Proposed Amendments to the Approved Yuen Long Outline Zoning Plan No. SYL/25

Detailed Departmental Comments

(規劃申請編號: Y/YL/18)

Checked	DH	Drawn	PW
Rev	0	Date	Apr 2022
Scale		Figure	A1

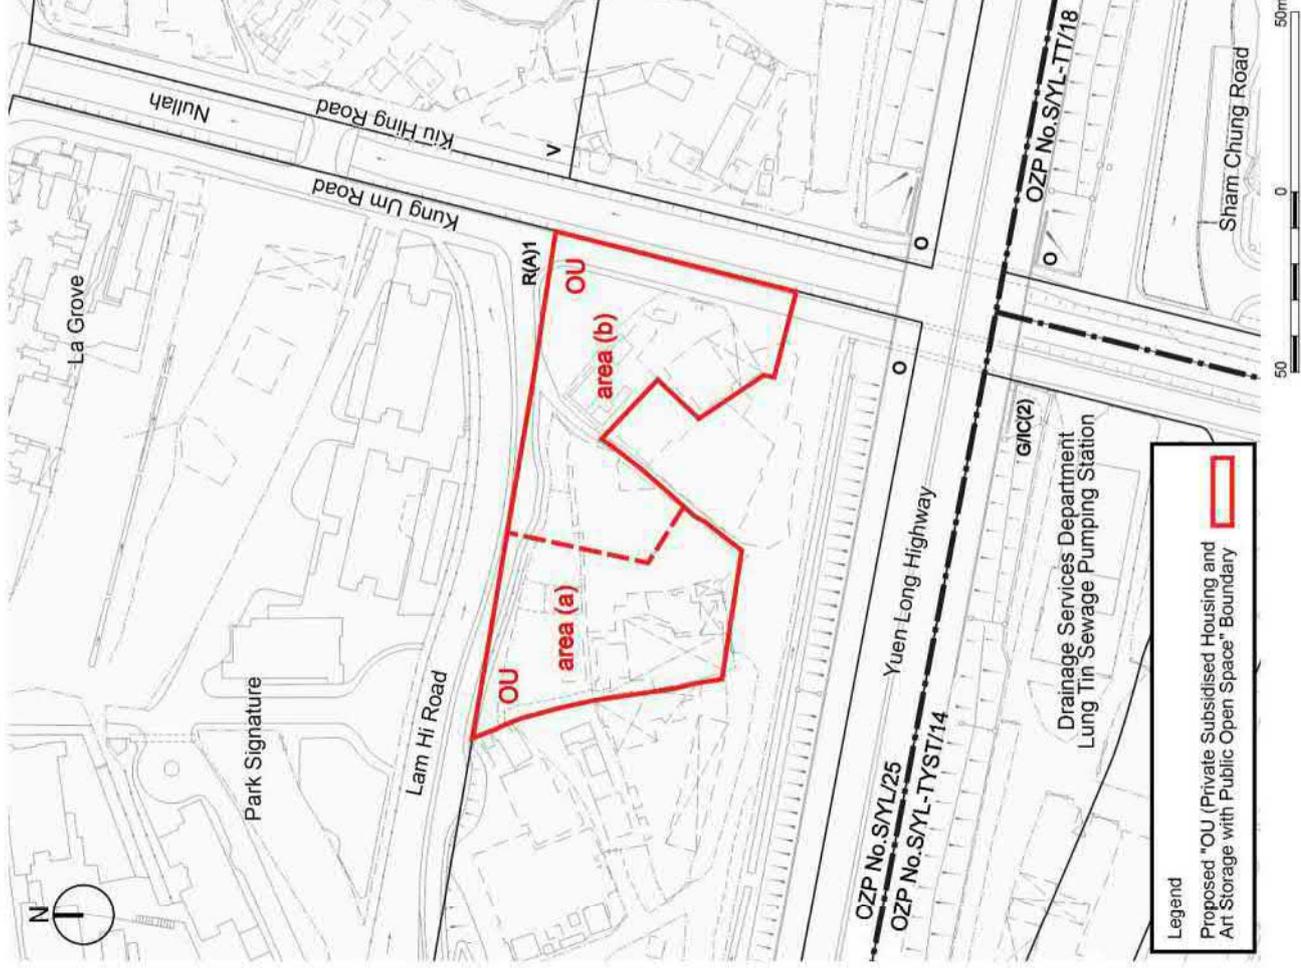
- (a) *No new development, or addition, alteration and/or modification to or redevelopment of an existing building within Area (a) (Private Subsidised Housing Portion) shall result in a total development and/or redevelopment in excess of a maximum domestic plot ratio of 5 and a maximum building height of 25 storeys (above ground), whereas within Area (b) (Art Storage Portion) a maximum gross floor area of 5,968m² and a maximum building height of 23mPD. Public open space of not less than 590m² shall be provided.*

- (b) *In determining the maximum gross floor area for private subsidised housing purpose of paragraph (a) above, any floor space that is constructed or intended for use solely as car park, loading/unloading bay, plant room and caretaker’s office, or caretaker’s quarters and recreational facilities for the use and benefit of all the owners or occupiers of the domestic building or domestic part of the building, provided such uses and facilities are ancillary and directly related to the development or redevelopment, may be disregarded.*

- (c) Based on the individual merits of a development or redevelopment proposal, minor relaxation of gross floor area and building height restrictions stated in paragraph (a) above may be considered by the Town Planning Board on application under section 16 of the Town Planning Ordinance.
